Memorandum

Re: Cold Brook Crossing – Sudbury, MA
Responses to 4-23-2020 Wastewater Peer Review by Horsley Witten Group

**LEACH FIELD
SETBACK TO
FOUNDATIONS**

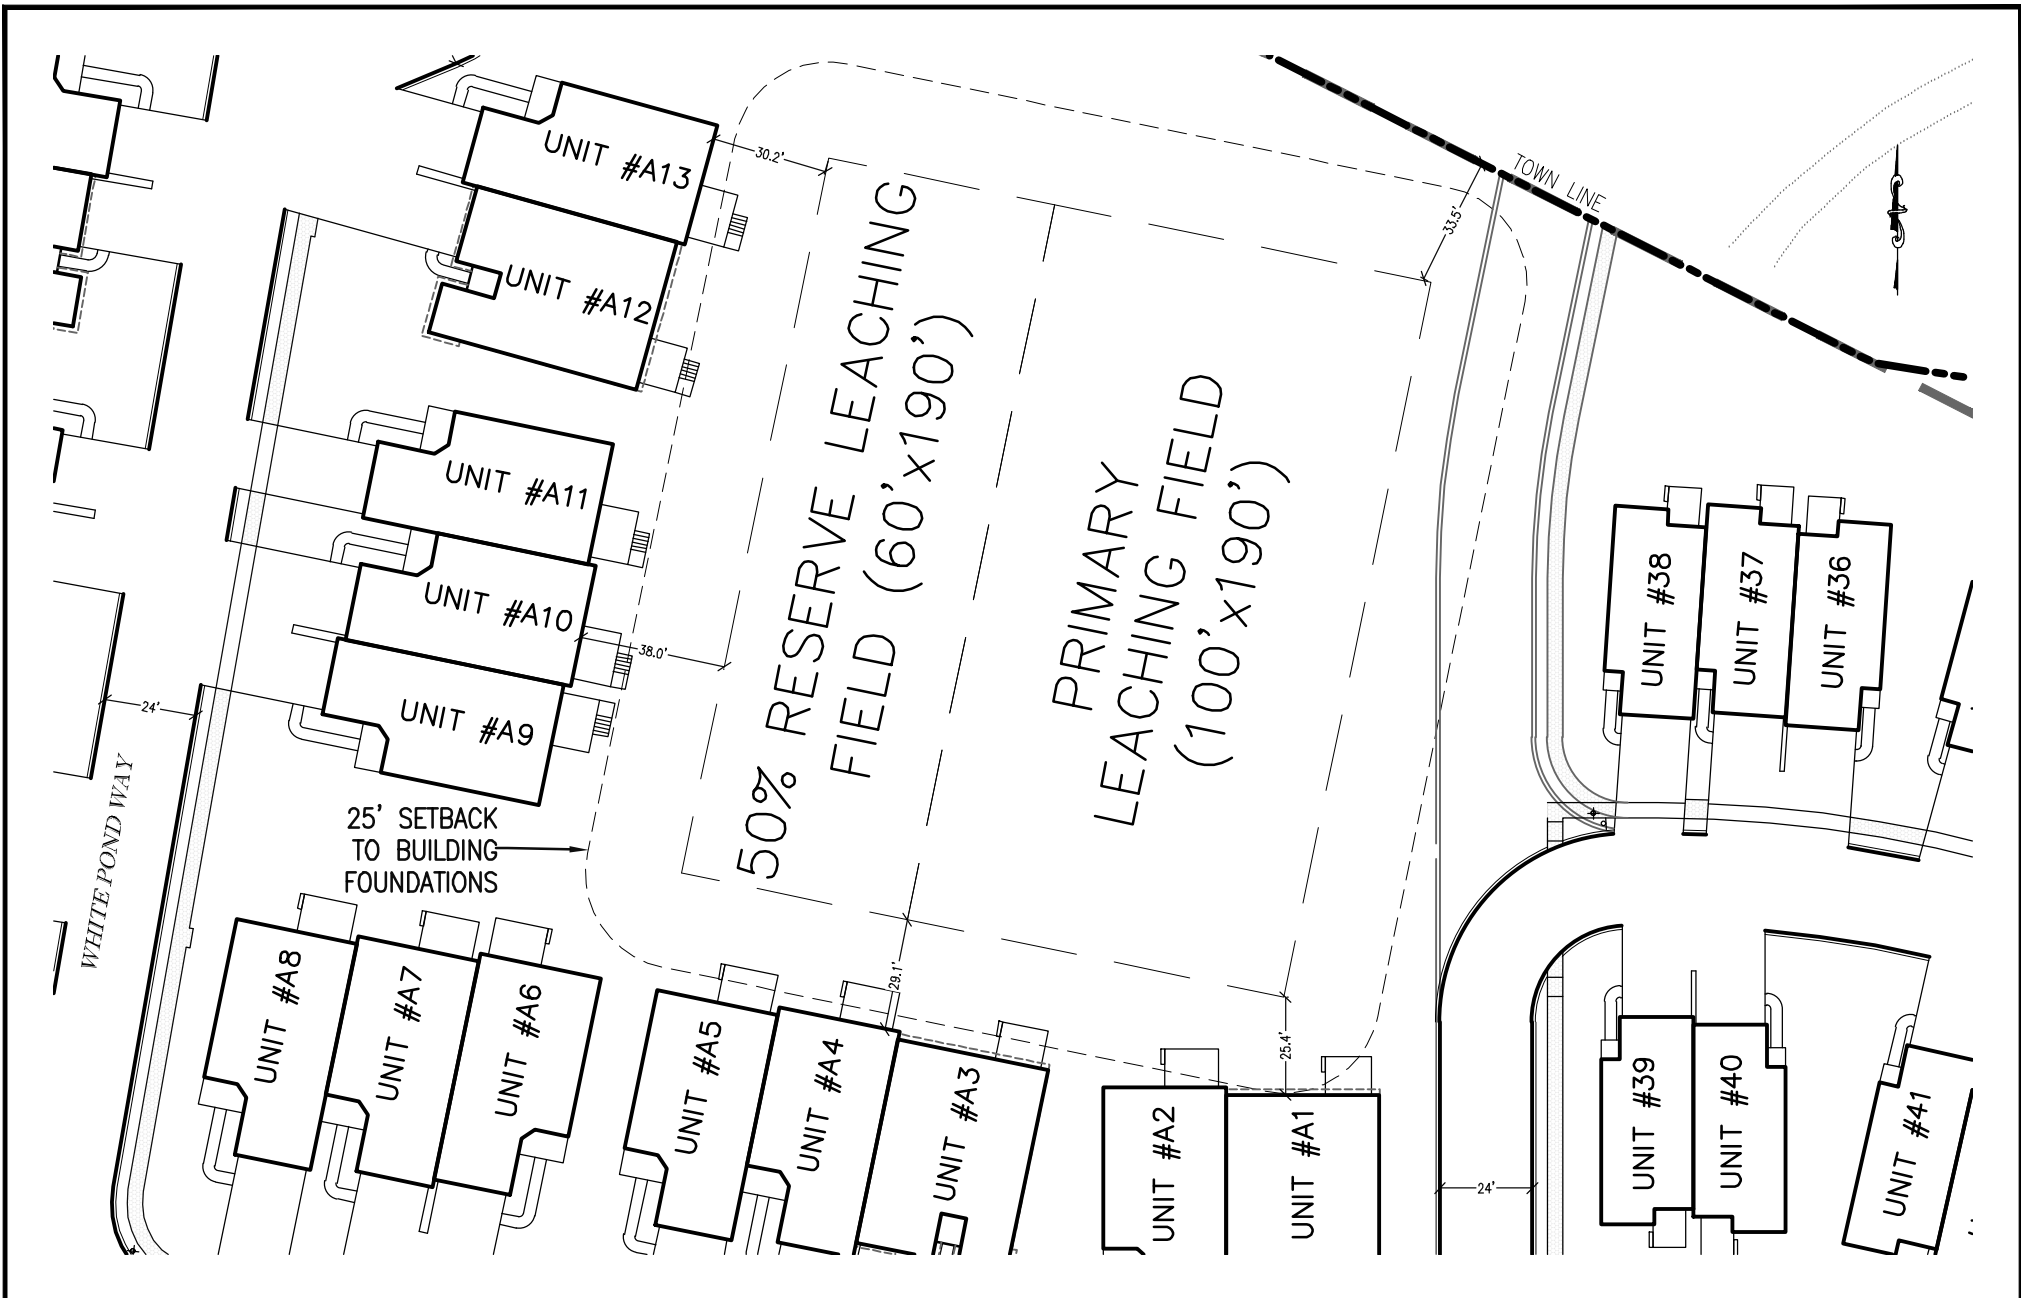
The design plan should show the setback requirement to all basements surrounding the leach field and reserve leach field area.

The attached exhibit shows the required 25' setback and provides dimensions from the leach field to all adjacent building foundations. These dimensions are also included on Layout Plan C (sheet 9 of the submitted plans).
